# **Comments for the draft\* of ASEP measurement and analysis method**

**\* Issued by the Netherlands on 26-9-2006**

**JASIC**

**GRB informal Meeting No. 5**

# The sound slope 'b' (without tyre noise)

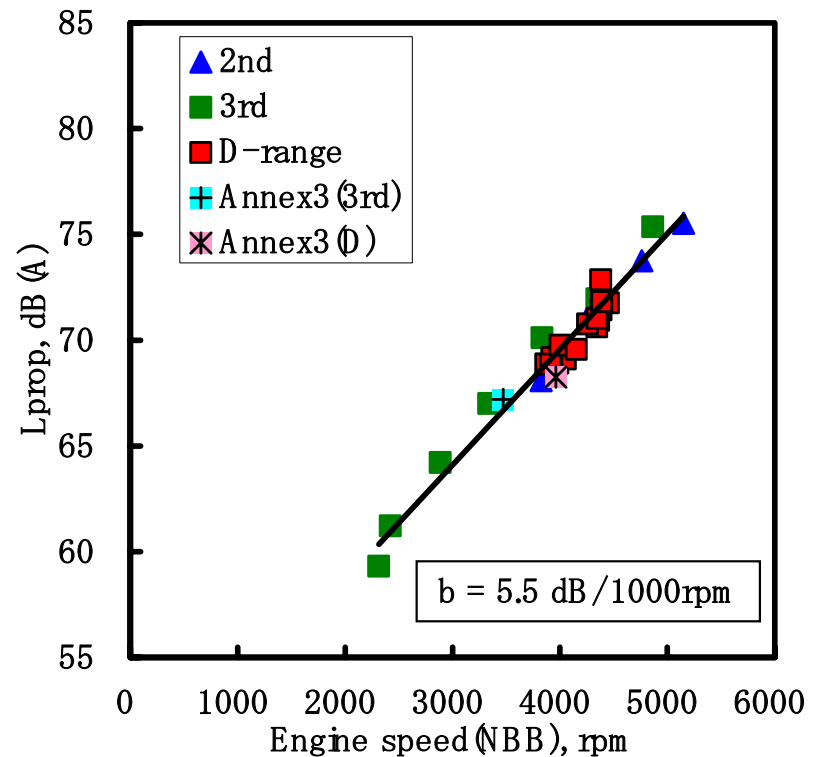
**Both sound level of fixed gear and D range are on the same regression.  
The slope 'b' are larger than 5.**

# The sound slope 'b' (without tyre noise)

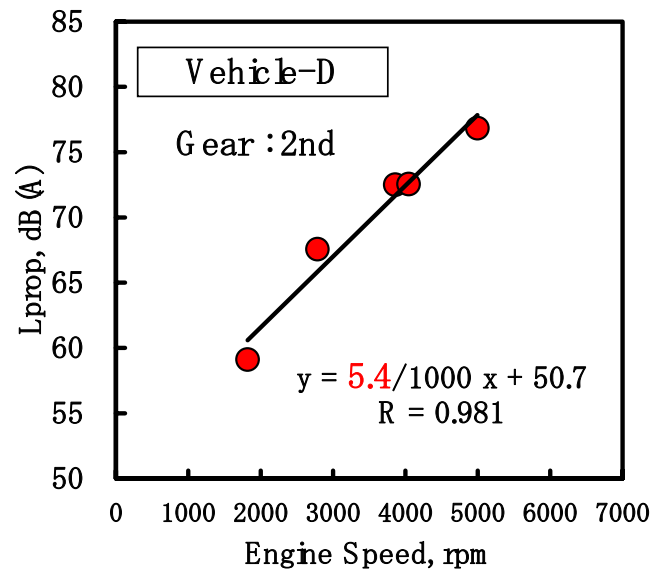
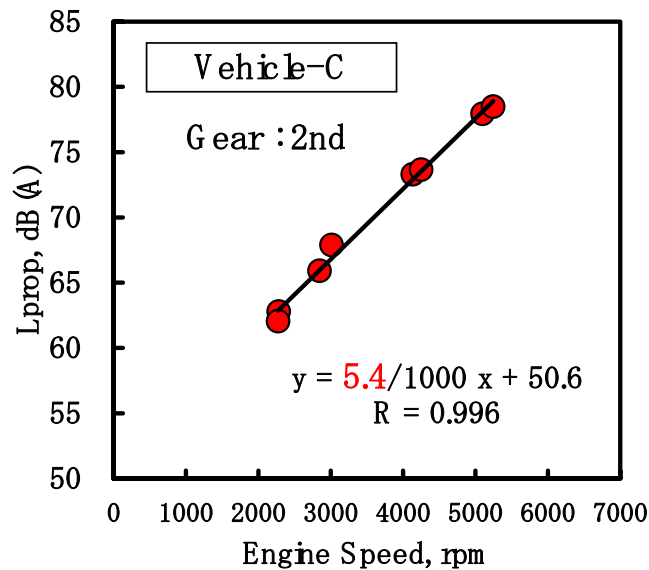
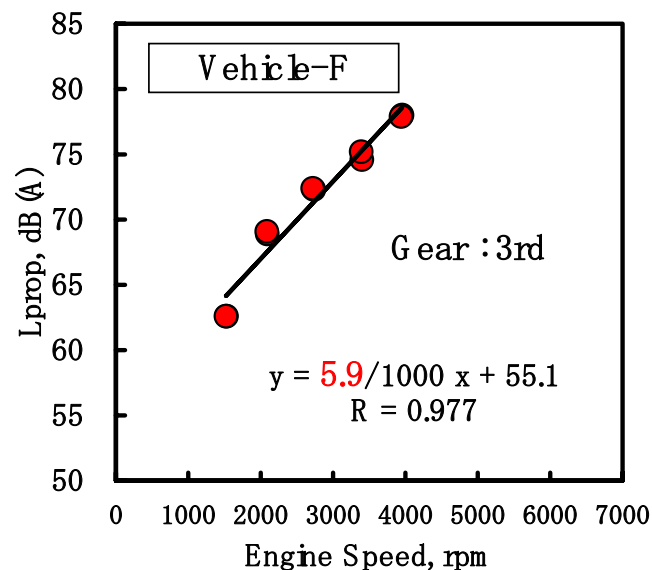
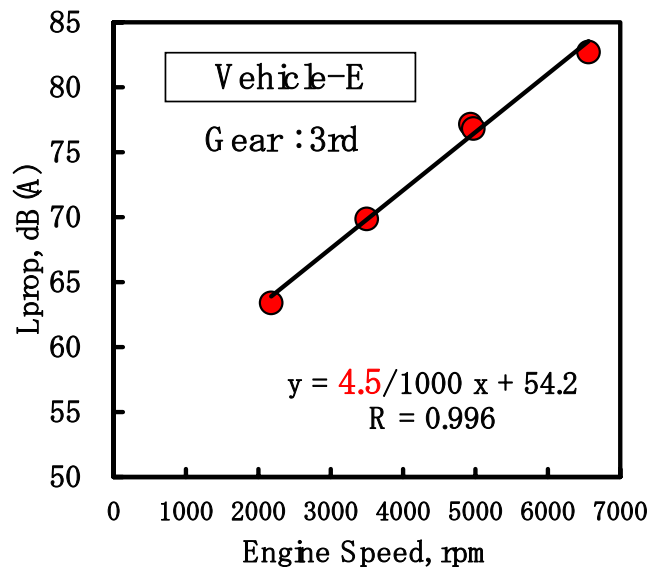
The sound slope 'b' for most of vehicles are larger than 5

# Data processing of the Netherlands proposal (Vehicle-B: CVT vehicle)

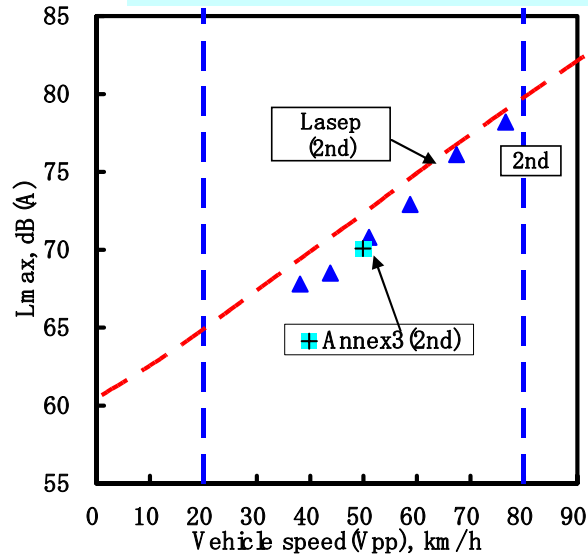
**This condition cannot be tested.**

# Data processing (AT vehicle A; D range)

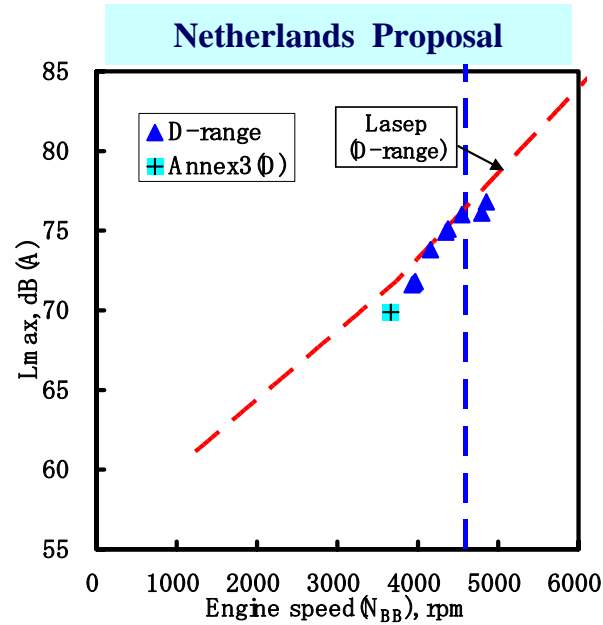
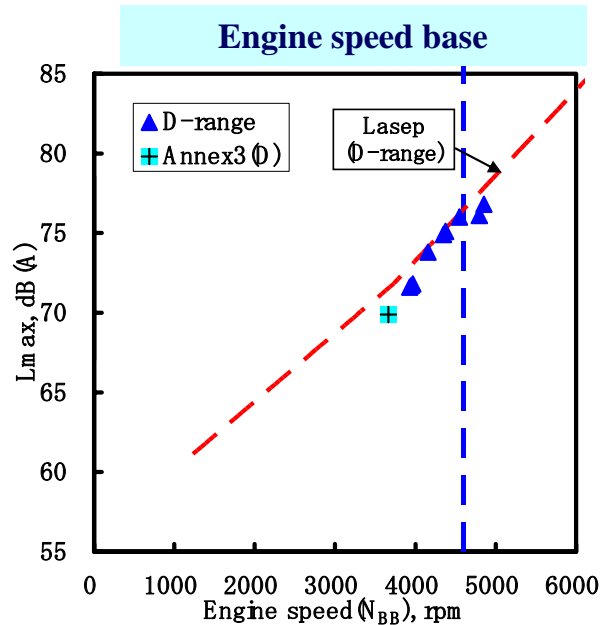
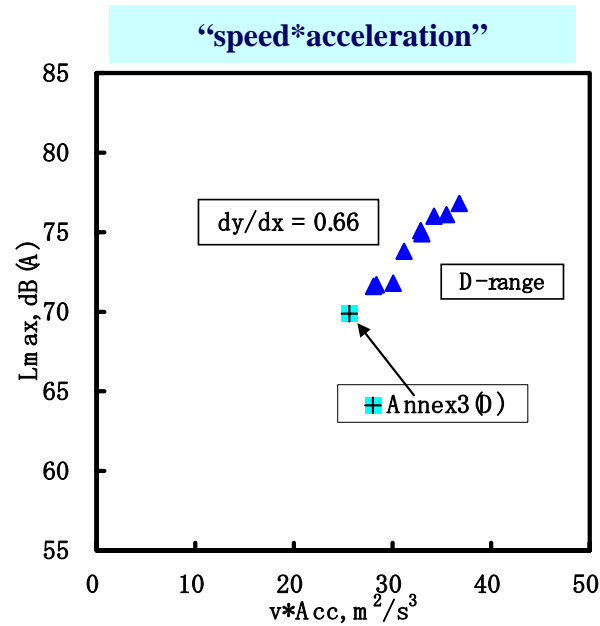
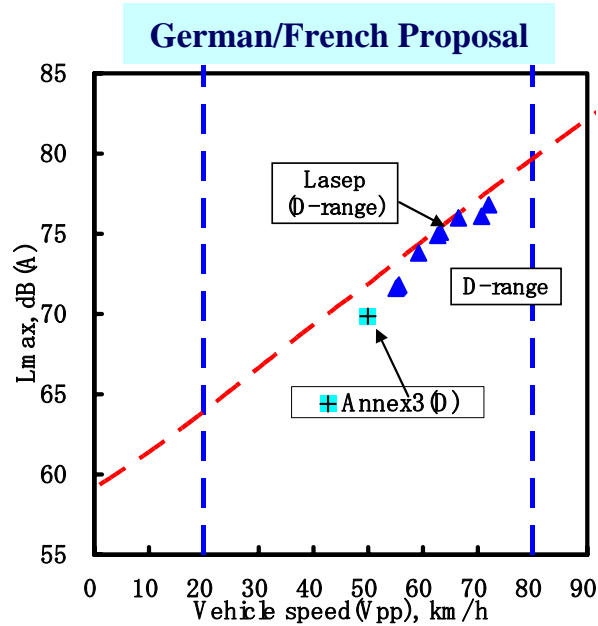
**The measurement below  $n_{ref}$  cannot be carried out.**

# Data processing (CVT vehicle B; fixed gear )

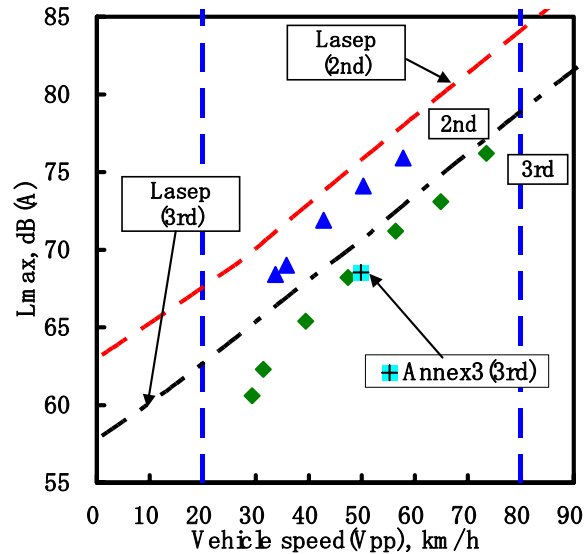
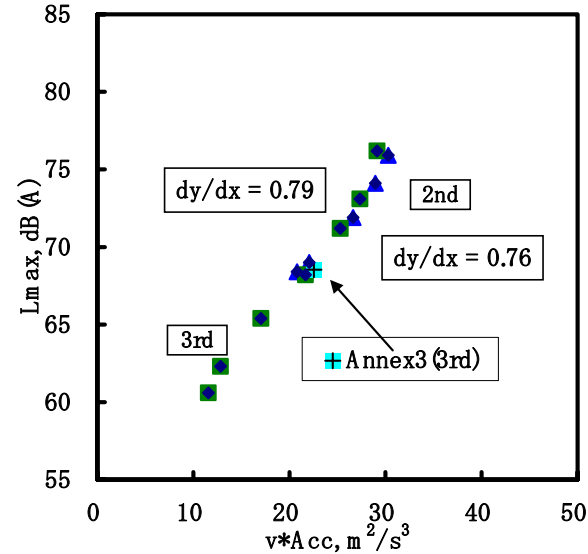
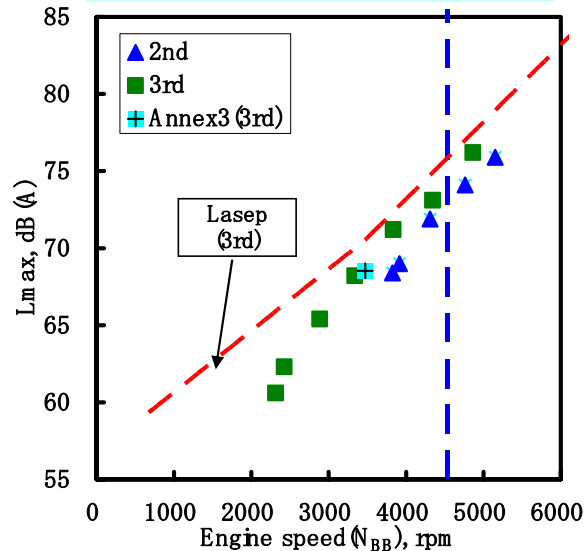
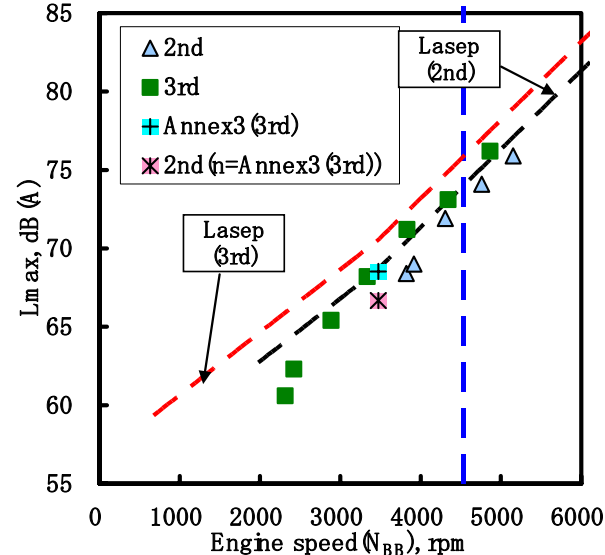
In case of G/F and NL proposal, each gear has to have individual reference line.

The difference of sound level for different gears (D) is 1.5dB.

# Data processing (CVT vehicle B; D-range)

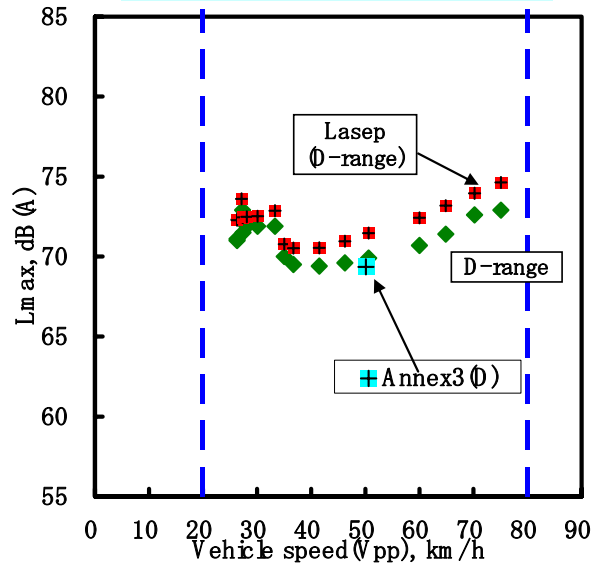
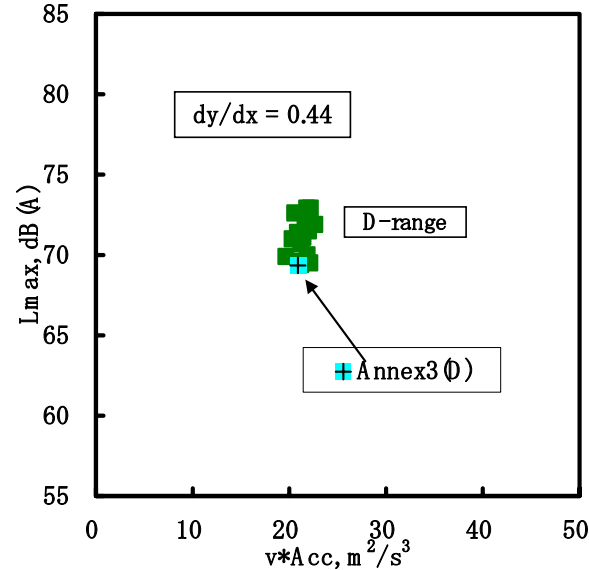
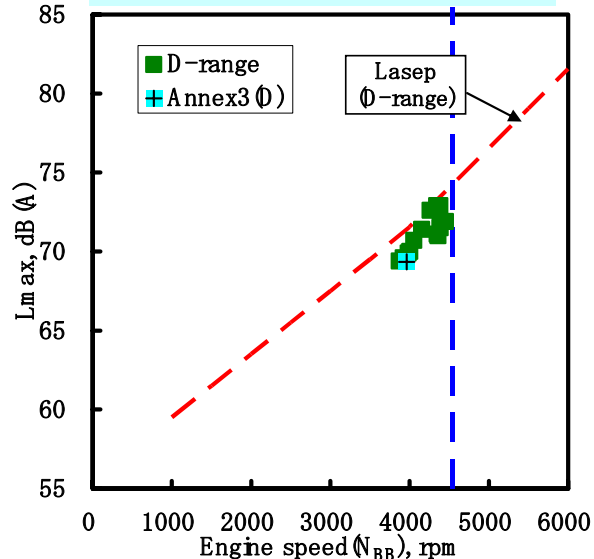
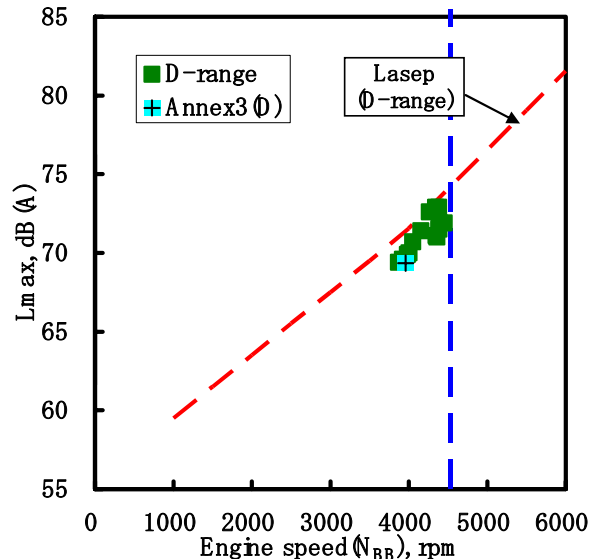
No reference line can be drawn in the case of the CVT vehicle in G/F and  $v \cdot a$ .

The measurement below  $n_{\text{ref}}$  cannot be carried out.

Is it necessary to measure below  $n_{\text{ref}}$  and four measurements among 500rpm?

## Vehicle-B

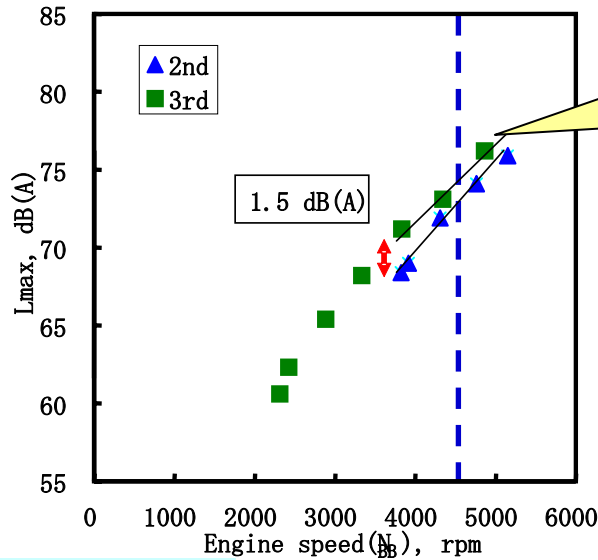
The difference of sound level by the gear position

3rd gear test cover up to target engine speed.  
2nd gear test is not necessary.

The difference of sound level for different gear positions (D) is 0~1.5dB.

# Number of Test Runs

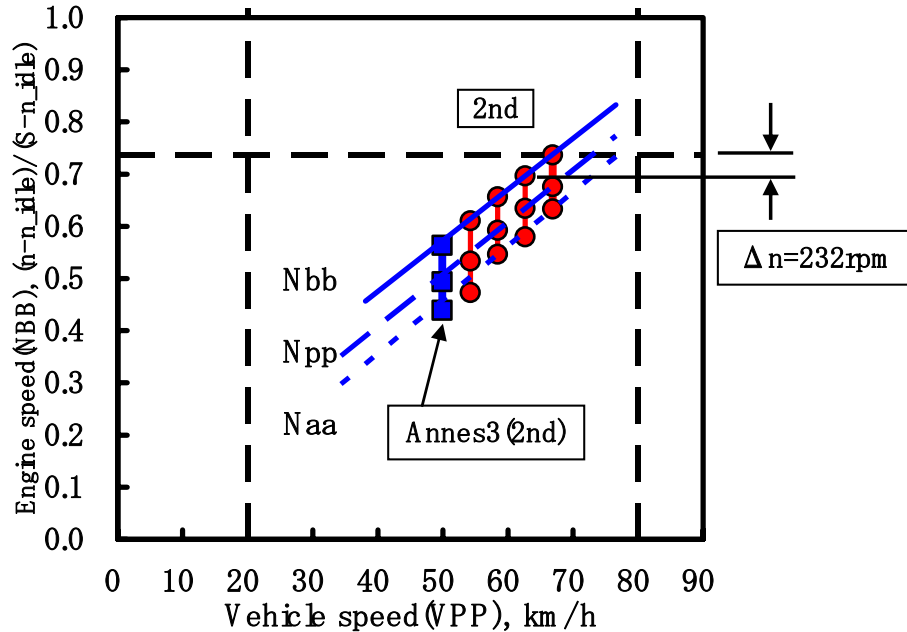
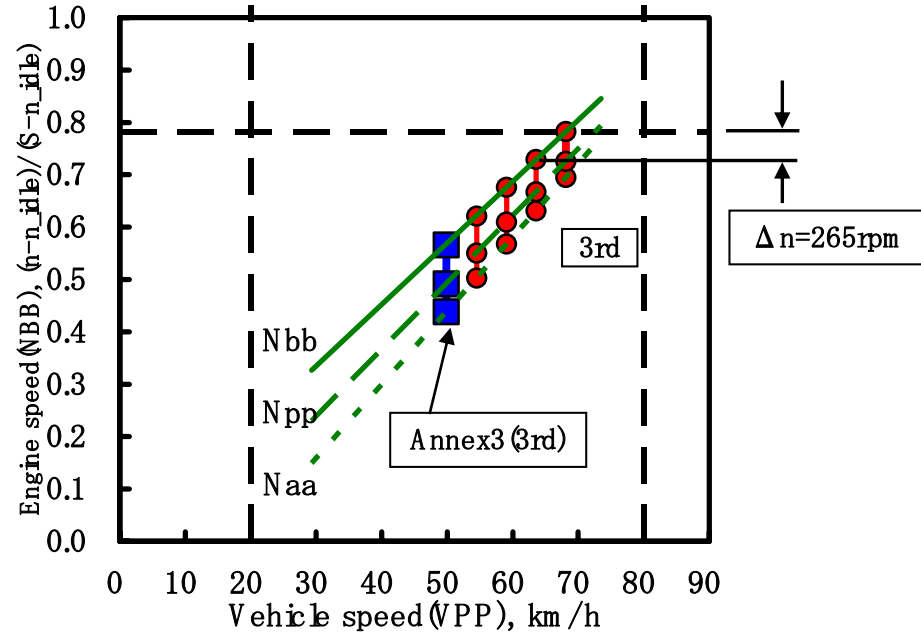
When four measurements shall be carried out at  $n_{ref}$  to the target engine speed, every 250rpm measurements have to be done.

It seems that one or two runs are enough to cover to the target engine speed.
